TECHNICAL NOTE

Job Name: Ebbsfleet Riverside
Job No: 46600/4001
Note No: TN002
Date: 08 July 2021
Prepared By: M Grabowiecka
Subject: Northfleet Mixed Use Development -Robins Creek Hydraulic Modelling

This Technical Note 002 is intended to address comments received from the Environment Agency in May 2021 on Flood Risk and Flood Modelling.

Figure 5 Long Culvert long section – max WL 1% annual probability event with 35% climate change and 70% climate change increase (blue – baseline, red – PD_101, green – PD_201)

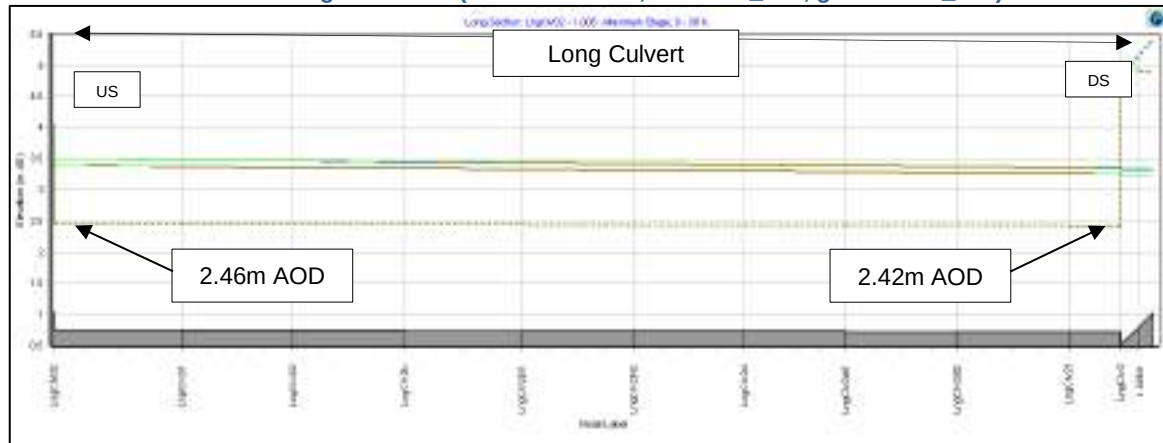
- The freeboard of 400mm for Robin's Creek should be revised and explanation should be included in the report how the value has been arrived at?*

Based on the Post Development models analysis, the maximum water level of 2.7m at the Creek occurs at 1% annual probability event with 70% climate change increase scenario PD_202. For 1% annual probability event with 35% climate change increase the maximum water level is at 2.62m AOD. Bank levels for the Creek as indicated on the **Figure 2** are higher, with the lowest bank point of 3.1m AOD north of the Creek. This indicates, that by adding additional outflow from proposed development, there is negligible impact in flood risk at the Creek and the freeboard of 0.48m (3.1m AOD – 2.62m AOD = 0.48m) for 1% annual probability event with 35% climate change increase and freeboard of 0.4m (3.1m AOD – 2.7m AOD = 0.40m) for 1% annual probability event with 70% climate change increase is maintained.

Figure 7 Highest Astronomical Tide Sensitivity Analysis

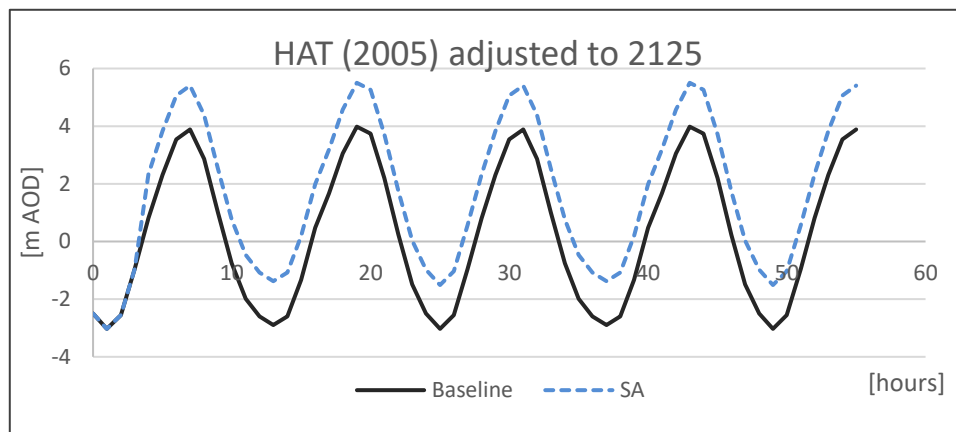
5. *A fluvial event could occur during a high tide causing tidal locking. Whilst this will be offset by storage afforded by Robin's Creek, under such scenario flood extents and depths could be more significant to those predicted in the updated baseline model runs. This comment should be addressed by better representation of climate change inducted sea level rise over the next 100yr.*

The downstream boundary of the Ebbsfleet model is at the confluence between the River Ebbsfleet and the River Thames. As agreed with the Environment Agency, 2005 model used the Highest Astronomical Tide (HAT) for the River Thames at Robins Creek as the downstream boundary condition for all updated baseline fluvial scenarios. A HAT event represents the highest tide level which can be predicted to occur under average meteorological conditions. The peak level on the tide curve was 3.98m AOD.

A similar approach was used for all the baseline (BA_002), sensitivity analysis and Post Development runs (PD_101 and PD_201).

For the downstream boundary sensitivity analysis, the Environment Agency guidance has been used to assess total potential change anticipated for the 2125. The 'south east' upper end sea level rise allowances for Thames river basin district have been applied and a cumulative sea level rise to 2125 of 1.52m was calculated. That value has been added to tide profile giving the peak level on the curve of 5.5m AOD. The initial 4 hours of the tide has been modified to match the model initial conditions. See **Figure 7** for details.

Figure 10 inflow optimization sensitivity analysis - Gravesend

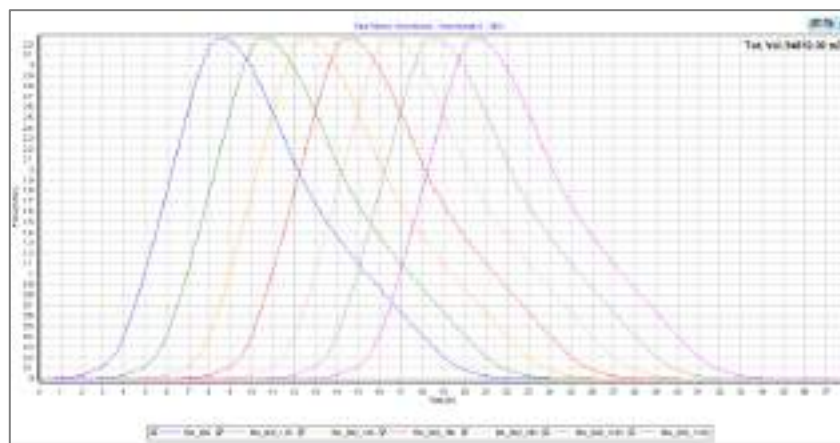
6. *The timing of the high tide should be optimised with the timing of the fluvial flood wave to assess the maximum water level that would be achieved in Robin's Creek and the resultant backwater effect that would propagate upstream.*

To assess potential changes resulting from optimisation of model inflows, sensitivity analysis has been undertaken with all inflows shifted +2hours, +4hours, +6hours, +8hours, +10hours and +12hours. See **Figure 10** for inflow example at Gravesend. Model has been run for both 1% annual probability event with 35% climate change increase and 1% annual probability event with 70% climate change increase.

Above analysis demonstrated that the worst-case scenario for 1% annual probability event with 35% climate change increase at Robins Creek is +2hours and for the 1% annual probability event with 70% climate change increase is +4hours with water levels of 2.59m AOD and 2.65m AOD respectively.
